NRL/MR/7441--94-7516

Digital Mapping, Charting, and Geodesy Analysis Program Technical Review of Vector Smart Map Prototypes 1 and 2

January 19, 1995

Figure 8 Water courses with apparent gaps

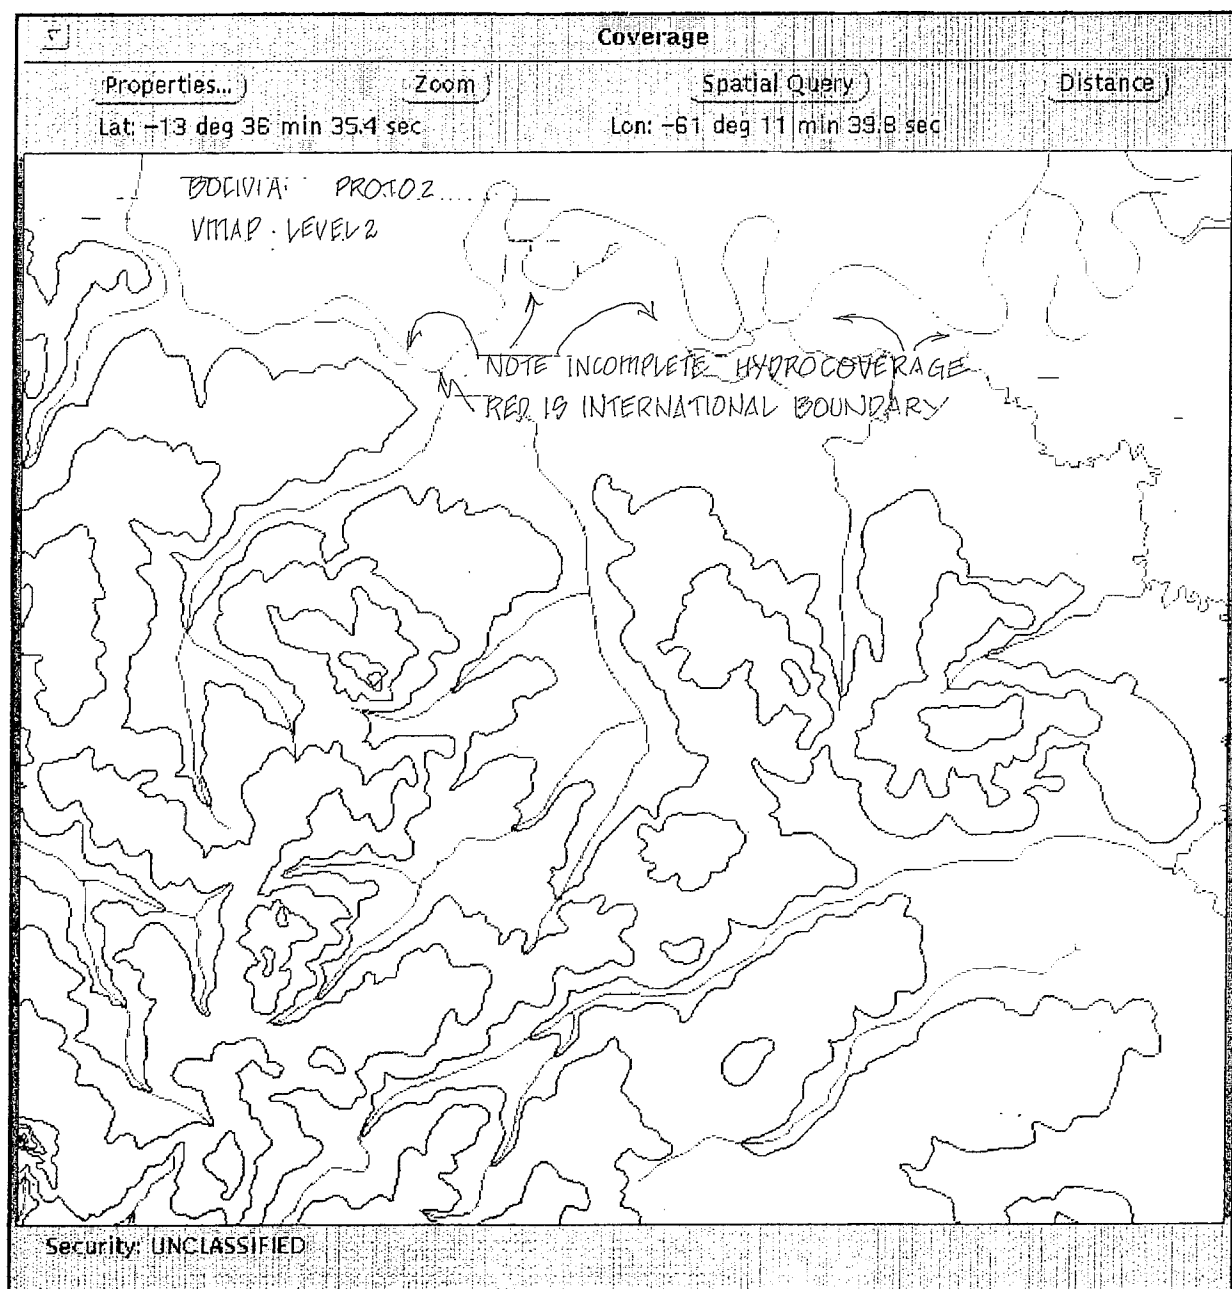
Figure 8 displays the water courses in the Hydrography coverage and political boundaries in the Boundaries coverage of the high resolution Bolivia data. Similar to the Level 1 Bolivia database, confusion resulted near the boundary. Water courses appear incomplete, when in actuality the area feature class Water Courses and Bodies "fill-in" the gaps.

Figure 9a. Construction of a query using Microsoft Access QBE editor

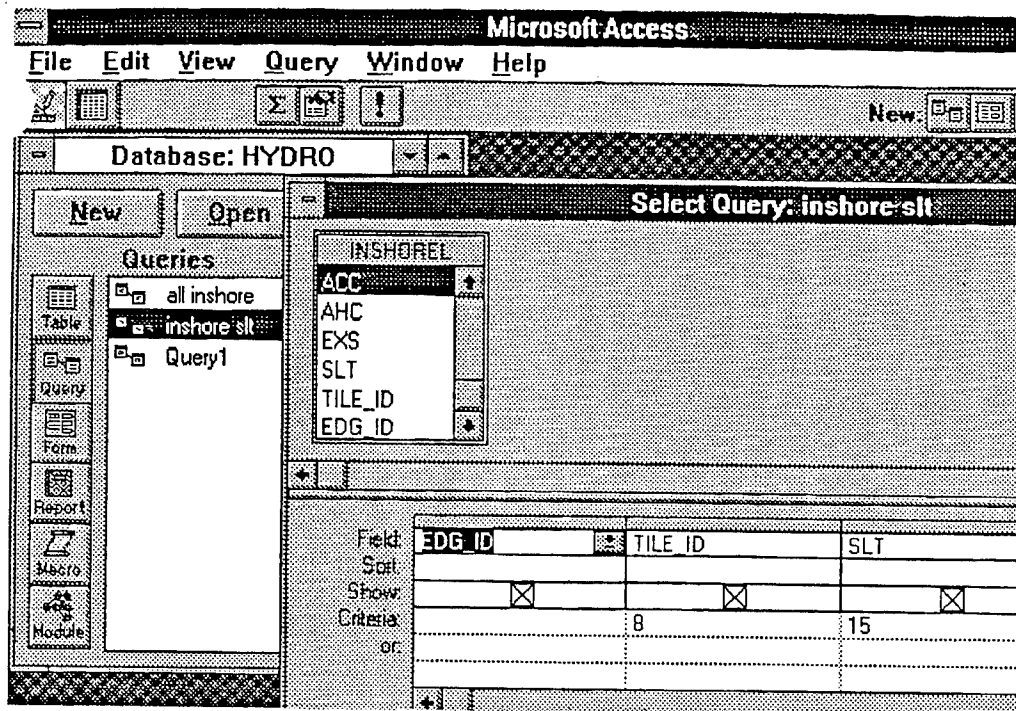
Figure 9a shows the construction of a query using Microsoft Access Query By Example (QBE) editor. The query accesses a single table, the Inland Shore Line Feature Table in the Hydrography Coverage, and is designed to list the EDG_IDs that are in TILE_ID 8 that have a Shoreline Type Category of "Other" (attribute value 15). Figure 9b is the spreadsheet view of the result of the query. It was noted that all of the rows in this table have a value of "Other" in the Shoreline Type Category. If none of the shorelines fit any of the categories, then either the categories are poorly chosen or the data were carelessly produced.

Figure 12. Overlay of V_{Map} and ITD built-up area features

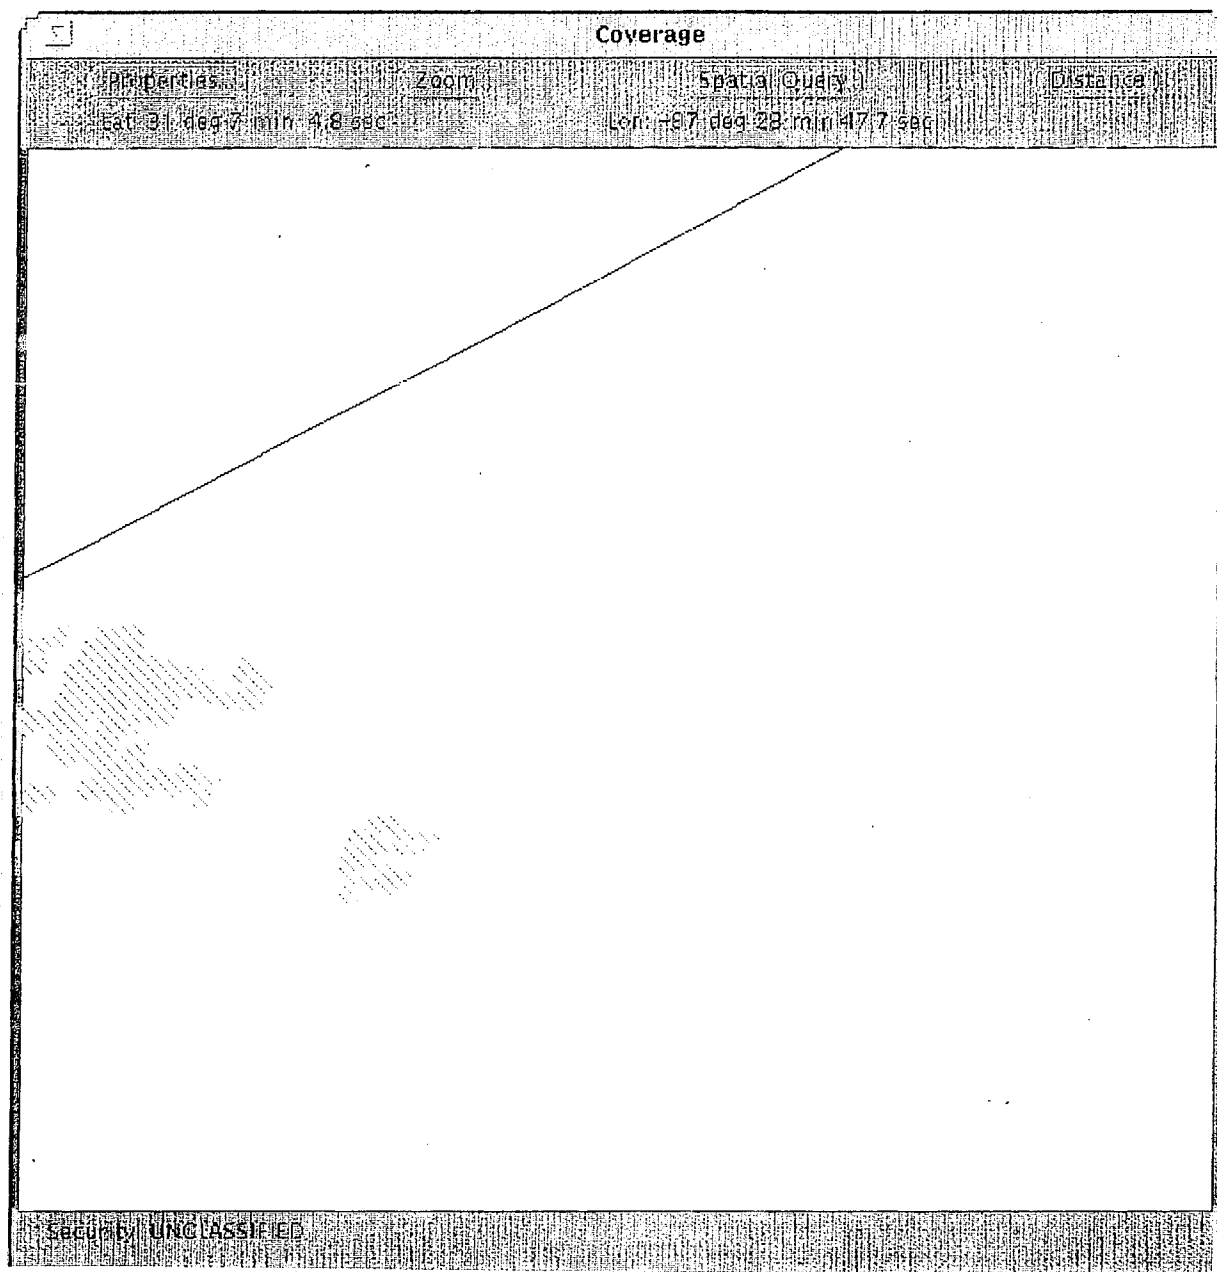
Figure 12 is an overlay of the Built-up Area (AL020) features in ITD and V_{Map} . ITD is represented in yellow and V_{Map} in diagonal red stripes. As can be seen, the Built-up areas in ITD are more extensive than in V_{Map} . This may be due to the different levels of attribution in each database. In ITD, Built-up Area has no attributes, but in V_{Map} it can be categorized by density. All of the Built-up Areas appearing in V_{Map} are classified as "Dense." The following question arises: Will V_{Map} contain only "dense" Built-up Areas, or were these the only Built-up Areas digitized for this particular implementation of V_{Map} ? In either case, assuming that ITD is correct, the remaining areas need to be added to V_{Map} .

Figure 13. Road/bridge discrepancies among V_{Map} , ITD, and source map

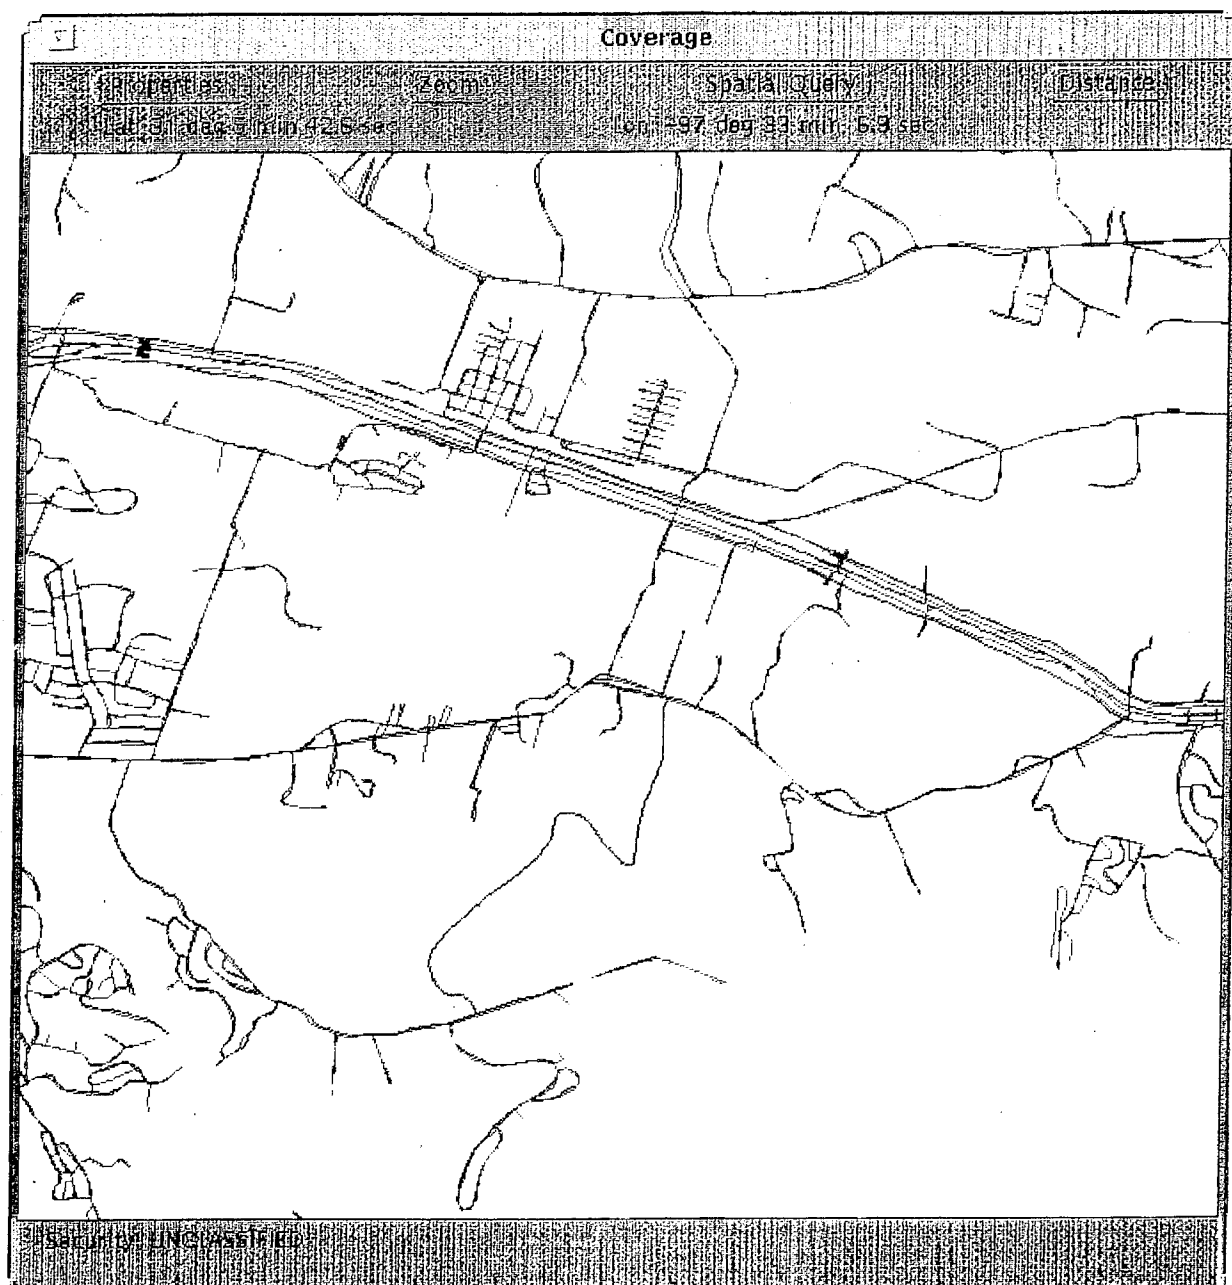
In Figure 13, ITD Roads (AP030) are blue and V_{Map} Roads are red, ITD Bridges (AQ040) are green, and V_{Map} Bridges are black. In the bottom center of the figure, a road classified as paved and all weather is included in ITD and not shown on the hardcopy map, sheet 6446 II, series V782, edition 5-DMATC, Killeen. There are also smaller roads of all types scattered throughout the figure that are omitted from ITD. Finally, in the northwestern corner of the figure, three bridges are depicted by V_{Map} , while none are shown by ITD.

Figure 14. Road/bridge discrepancies between V_{Map} and ITD

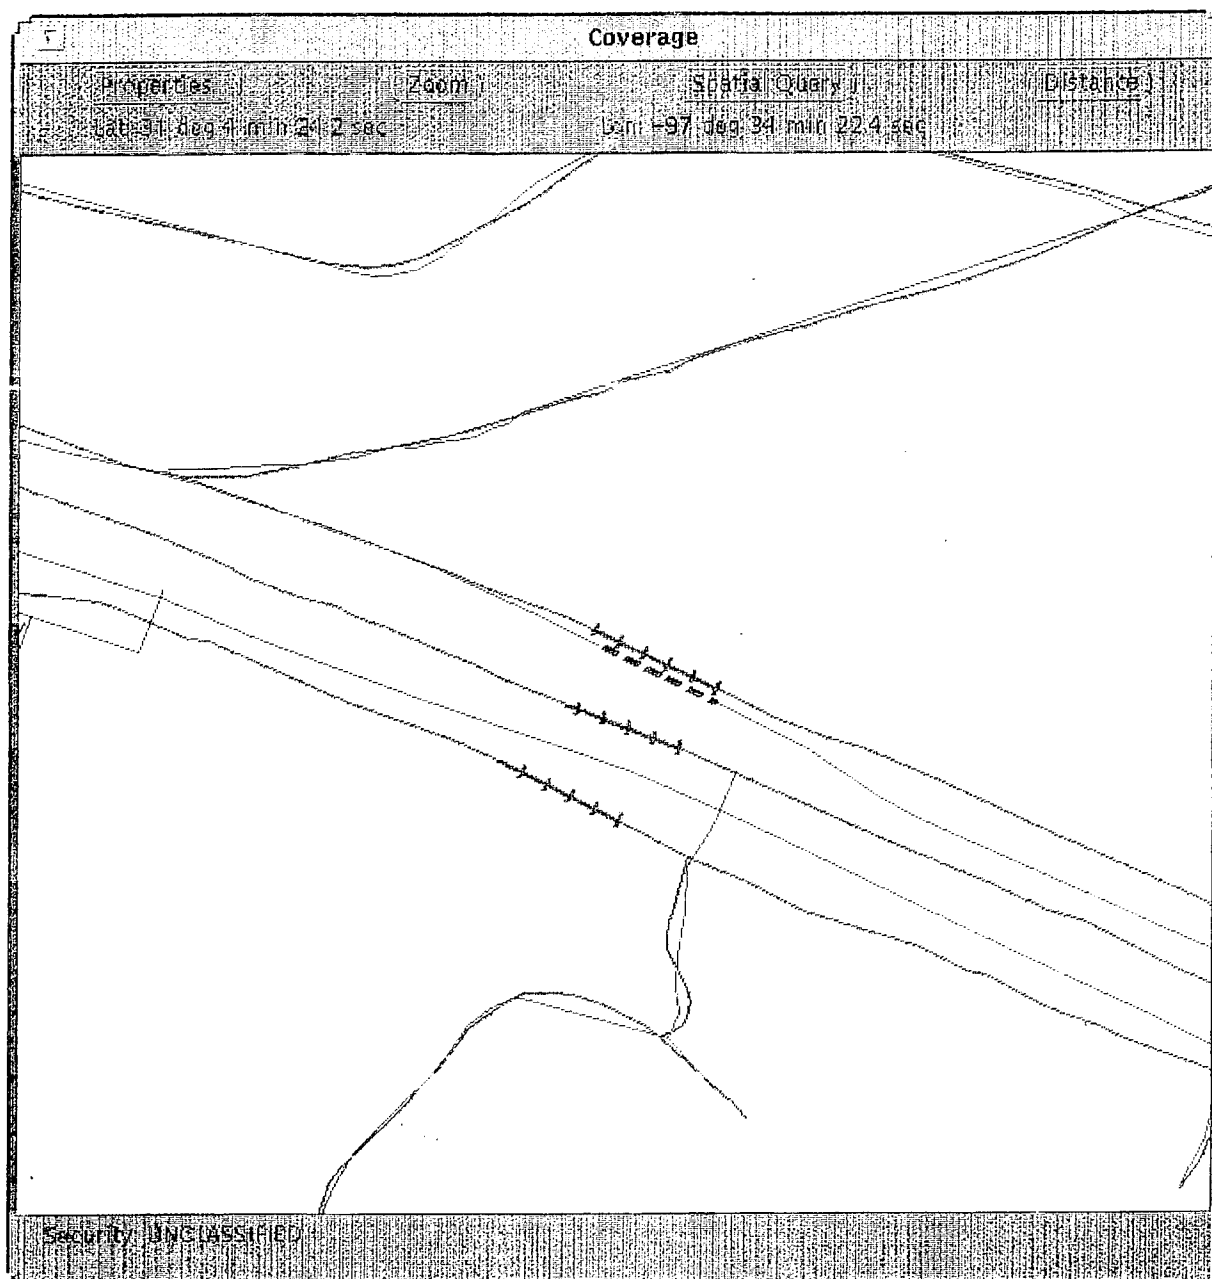
Figure 14 uses the same color scheme as Figure 13. In Figure 14 a section of highway is shown by ITD to have three bridges, but only one by V_{Map} . Also evident in this figure is the lack of agreement on the placement and shape of ITD and V_{Map} features. There is a constant offset between ITD and V_{Map} of .02 to .03 mi (106 to 158 feet) for all features in all coverages.

Figure 15. River/stream discrepancies between V_{Map} and ITD

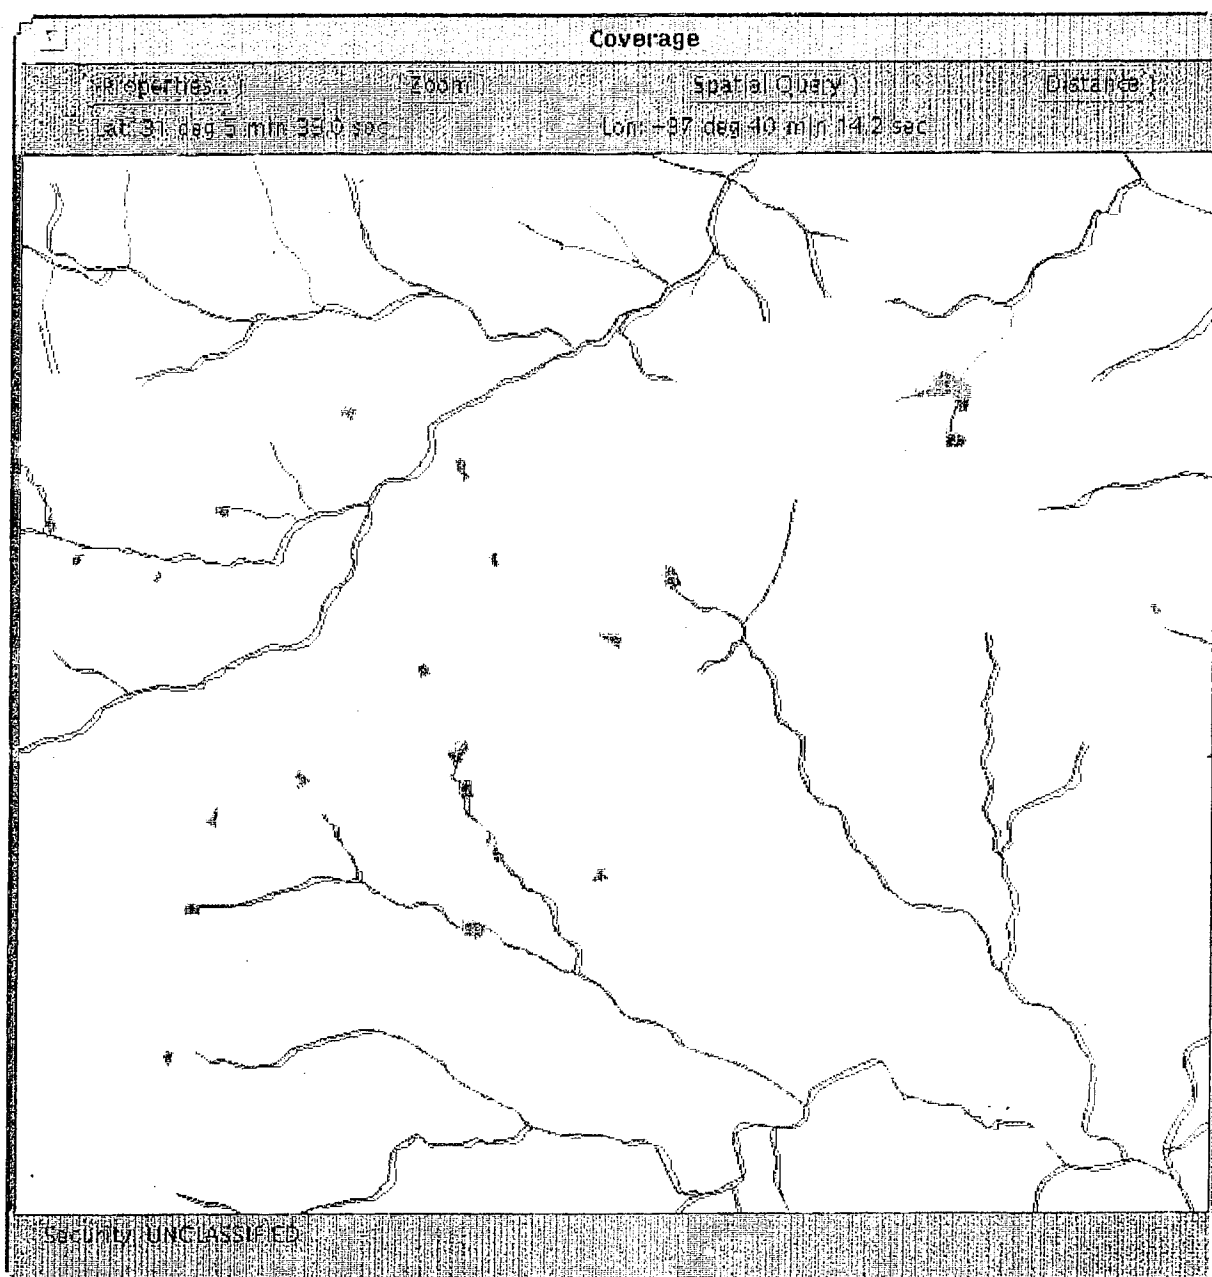
Figure 15 shows ITD River/Stream (BH140) line features in blue, V_{Map} River/Stream line features in red, V_{Map} Lakes/Ponds (BH080) in blue, and ITD Common Open Water (SA010) in orange. Of importance in this figure are the small Lakes/Ponds that are omitted from ITD and the various small river branches that are included by one database and not the other.

Figure 16. Reservoir classification disagreement between V_{Map} and ITD

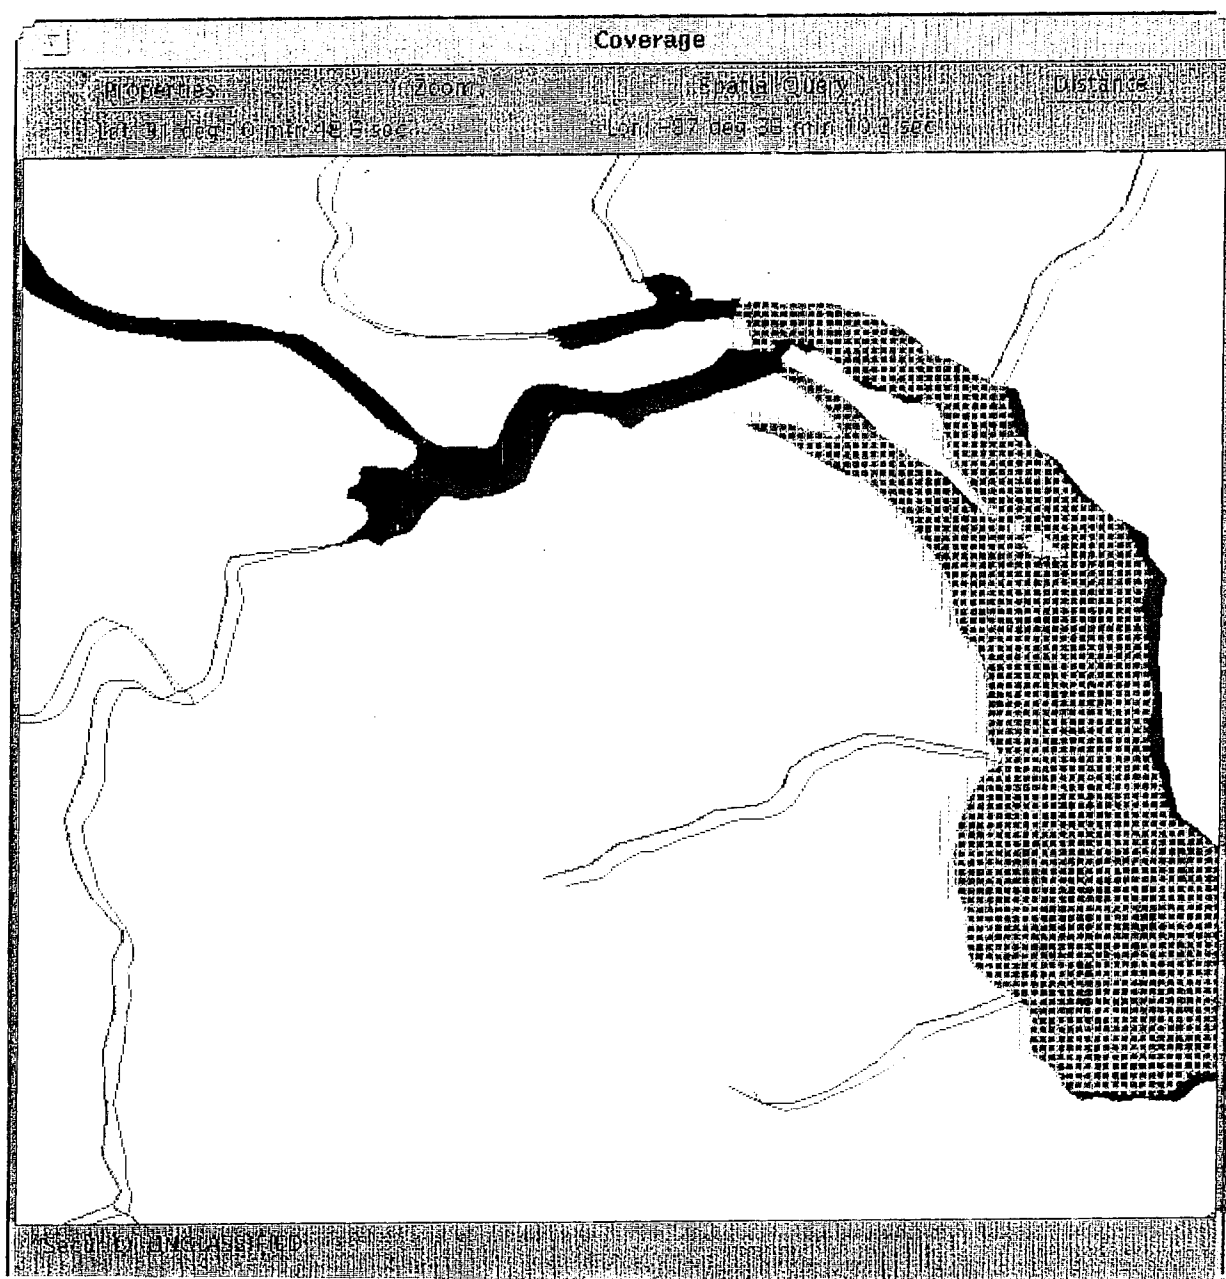
In addition to the features and color scheme of Figure 15, Figure 16 includes ITD River/Stream area features in dark blue, V_{Map} River/Stream area features in red, and Reservoir (BH130) in medium blue. This figure shows a disagreement on the classification of the extreme western end of the reservoir. ITD classifies it as both a river line and area feature, while V_{Map} labels it an extension of the reservoir area feature.
